Execution Ethernet Interfaces

1. Standard Ethernet TCP/IP interface

Typedesignation: BM4-O-ETH-01-00-00

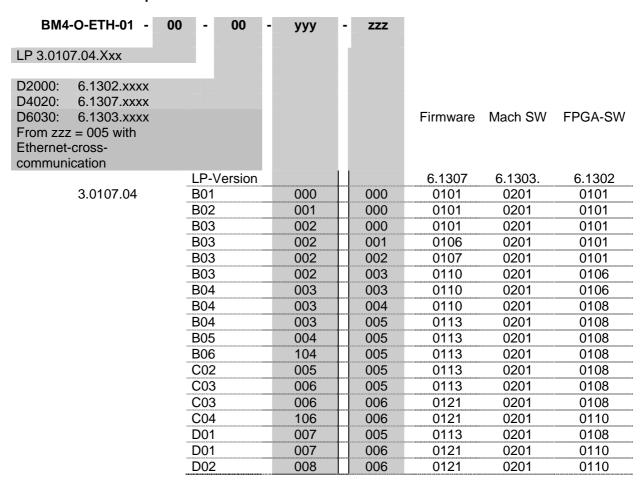
The printed circuit board 3.0107.04.B02 is introduced with AT161 03 from March 31, 2003.

• Adaptation of the parts list to the series production

The printed circuit board 3.0107.04.B03 is introduced with AT441_03 from October 01, 2003.

Internal change of the plug (solder instead of press)

The printed circuit board 3.0107.04.B04 is introduced with AT076 05 from April 04, 2005.

Optimized boot behavior (Reset level at the option modules)

The printed circuit board 3.0107.04.B05 is introduced with AT434_05 from December 16, 2005.

• Optimized for internal test equipment (additional resistors)

The printed circuit board 3.0107.04.C02 is introduced with AT434_05 from December 16, 2005.

• Optimized for the procedure of production

The printed circuit board 3.0107.04.C03 is introduced with AT196_06 from June 27, 2006.

Optimized assembly

The printed circuit board 3.0107.04.D01 is introduced with AT196 06 from June 27, 2006.

Optimized Layout

The printed circuit board 3.0107.04.D02 / C04/ B06 is introduced with AT215 07 from July 24, 2007.

Correction for error pattern ,Prozessor Abort During Data Access'

The FPGA-software 1.06 is introduced with AT076_05 from November 17, 2003.

- Synchronization behavior improves with restart of the synchronization
- Improvement of the BACI-Timing

The FPGA-software 1.08 is introduced with AT194_05 from June 17, 2005.

• Improvement of the signal quality (influence of the temperature)

The FPGA-software 1.10 is introduced with AT073 07 from March 2, 2007.

Standardization of software

The Firmware-software 1.06 is introduced with AT489_03 from November 14, 2003.

• Extension of the functionality on Multi Axis Motion Control

The Firmware-software 1.07 is introduced with AT111_04 from February 26, 2004.

Adaptation of the identification of new flash types

The Firmware-software 1.10 is introduced with AT076_05 from April 04, 2005.

- Synchronization behavior improves with restart of the synchronization
- Improvement of the BACI-Timing

The Firmware-software 1.13 is introduced with AT367_04 from June 22, 2005.

Qualities of all Firmware-versions (standard and cross communication) combines on a single firmware

The Firmware-software 01.21 is introduced with AT073 07 from March 02, 2007.

· Changes only in the software part of CANopen-Master

The changes are uncritically for the software. New software also runs on old hardware version.

Firmware and FPGA-SW always together update at last version. An update is possible only in BNE.

Typedesignation: BM4-O-ETH-01-00-01

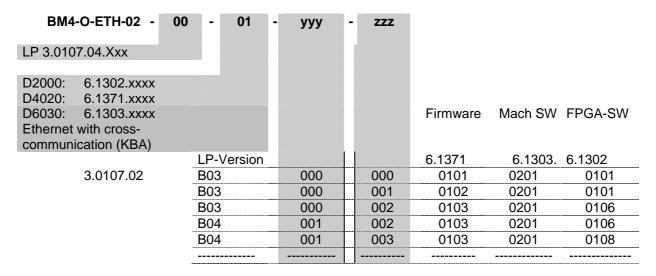
The printed circuit board 3.0107.04.B04 is introduced with AT076 05 from April 04, 2005.

Optimized boot behavior (Reset level at the option modules)

The FPGA-software 1.06 is introduced with AT076 05 from November 17, 2005.

- Synchronization behavior improves with restart of the synchronization
- Improvement of the BACI-Timing

The FPGA-software 1.08 is introduced with AT194_05 from June 17, 2005.

• Improvement of the signal quality (influence of the temperature)

The Firmware-software 1.03 is introduced from April 04, 2005.

- Synchronization behavior improves with restart of the synchronization
- Improvement of the BACI-Timing

This version is not any longer supplied. With introduction of the software 01.13 as compatible replacement the ETH01-00-00 is only manufactured.

Firmware and FPGA-SW always together update at last version. An update is possible only in BNE.
